SUPPLEMENT TO STANDARD
OPERATION AND MAINTENANCE
MANUAL

SACRAMENTO RIVER
FLOOD CONTROL PROJECT

UNIT NO. 118 - PART NO. 2
NORTH LEVEE OF AMERICAN RIVER
EAST LEVEE OF NATOMAS CANAL
BOTH LEVEES OF ARCADE CREEK
SOUTH LEVEE OF LINDA CREEK AND
MAGPIE CREEK DIVERSION CHANNEL

CESPD-CO-0 (CESPK-CO-0/29 NOV 89) (1130-2-320b) 3rd End Mr. Kress/om/705-1639
SUBJECT: Abandonment of Portion of Sacramento River Flood Control Project
Levee

UNIT 3 ARFLD

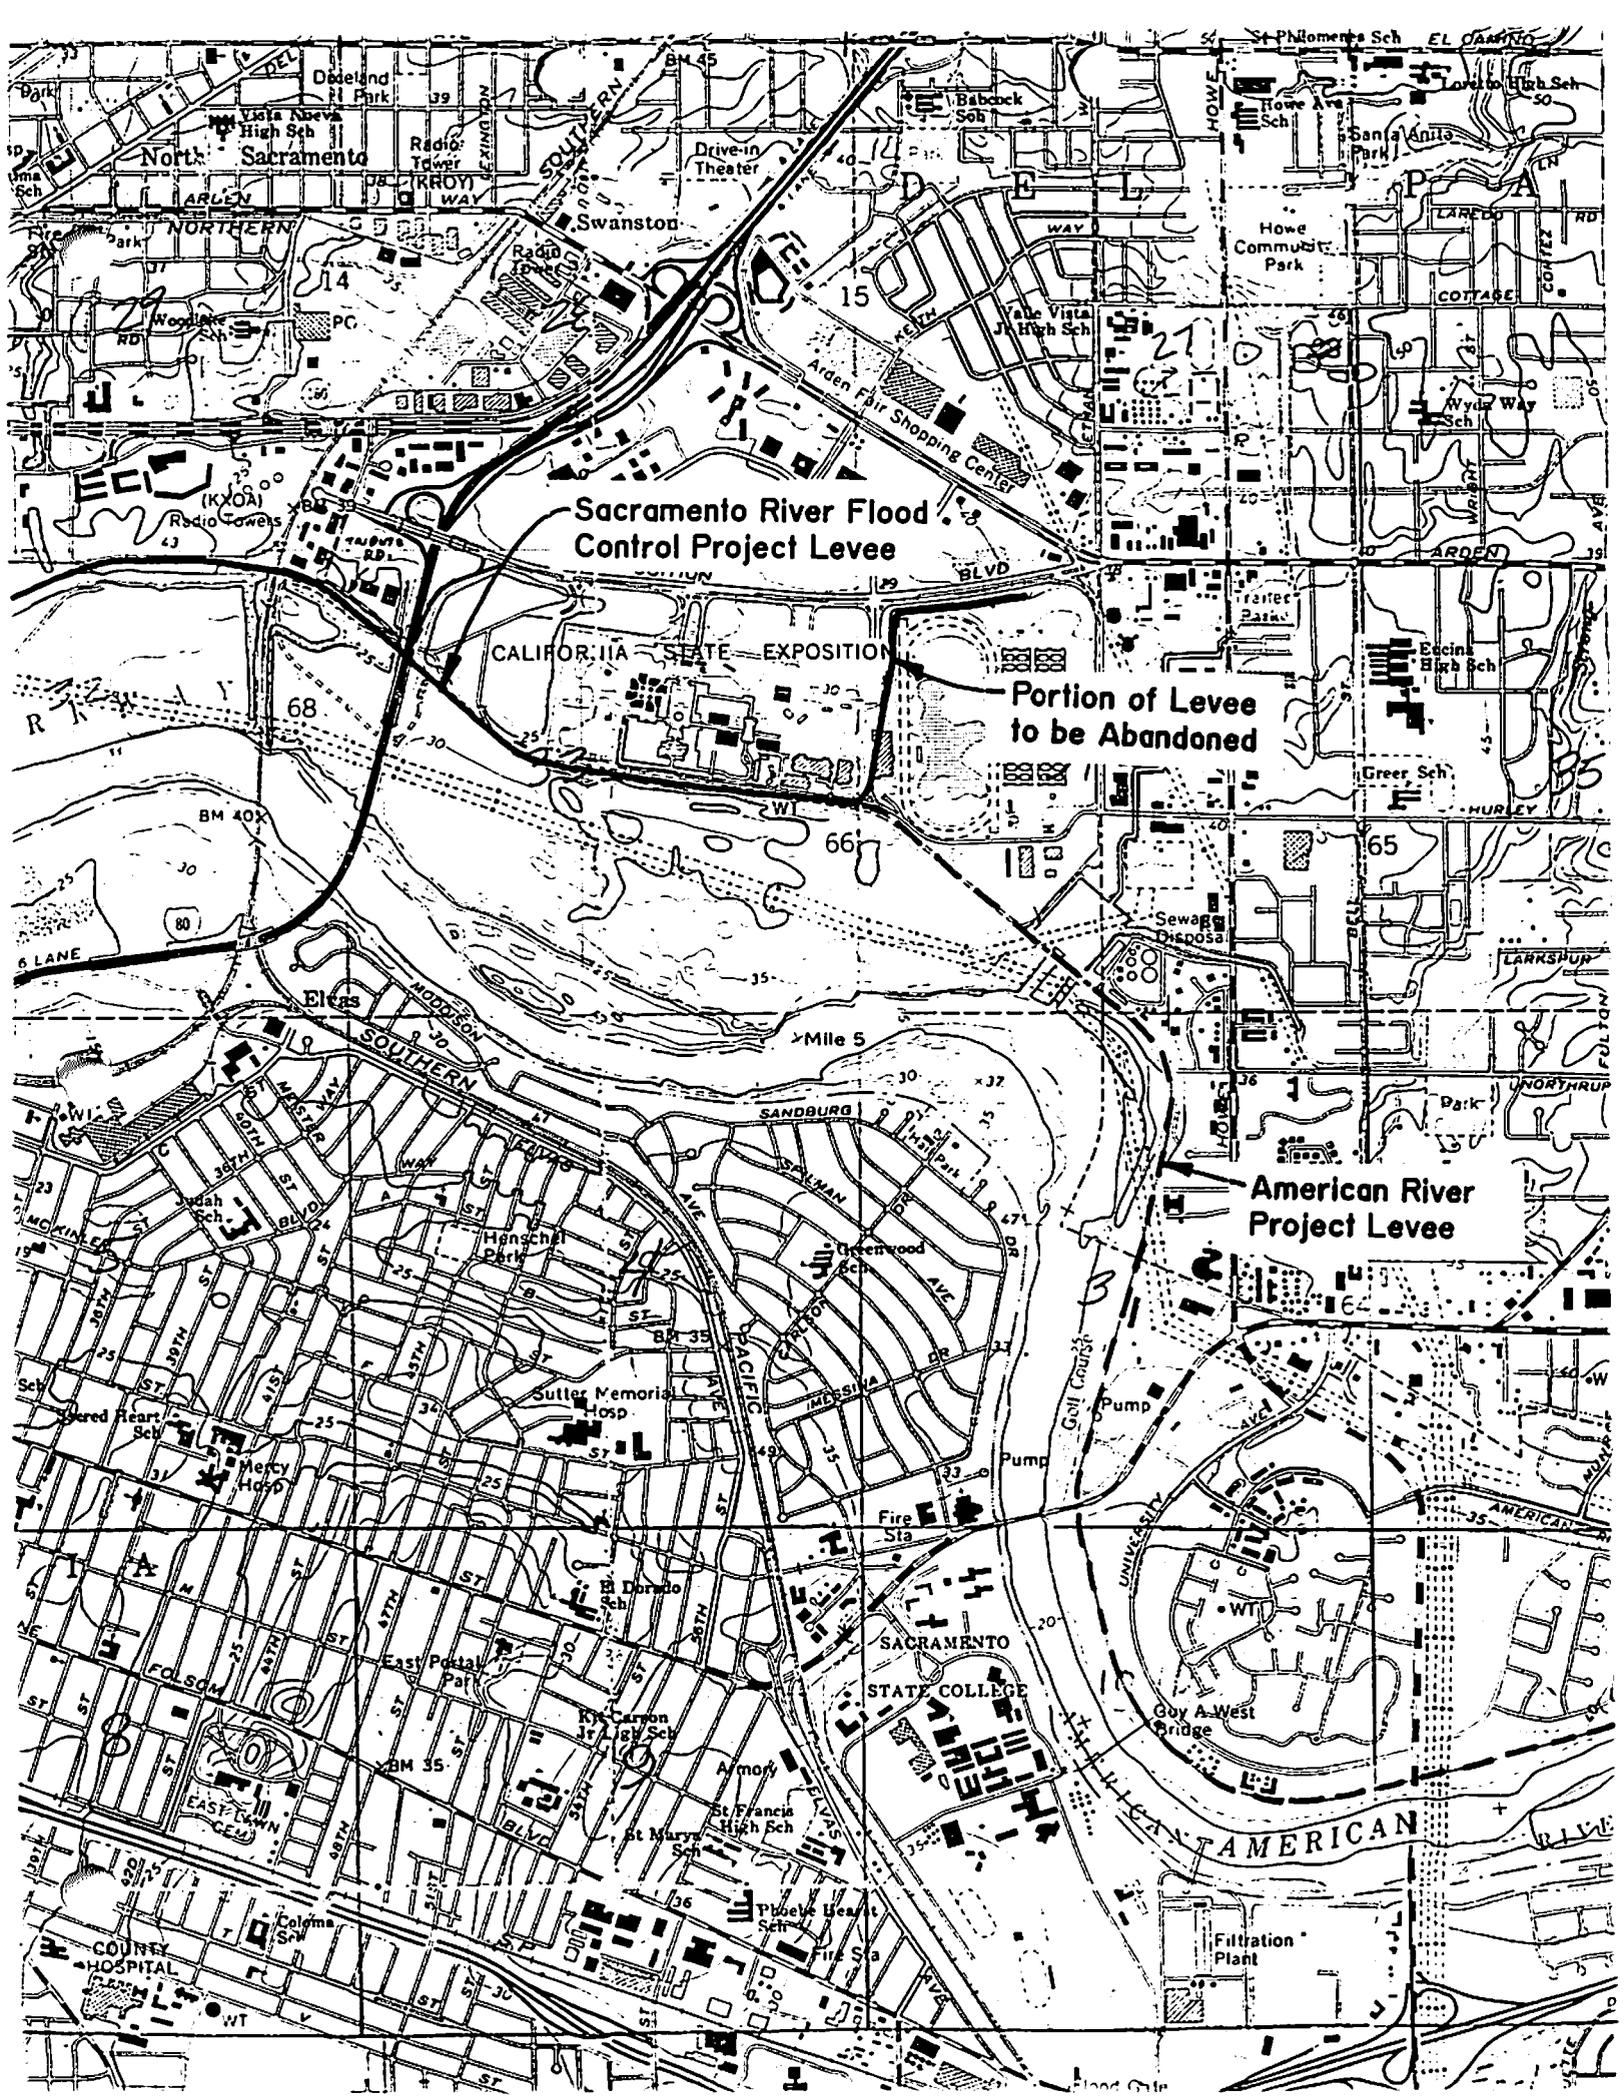
CAZ EXPO LEVEE WITHIN GROUNDS
OF CAZ EXPO (BEHIND GRANDSTAND)
REMOVED FROM PROJECT LEVEE
STATUS ON NOV 1 1989
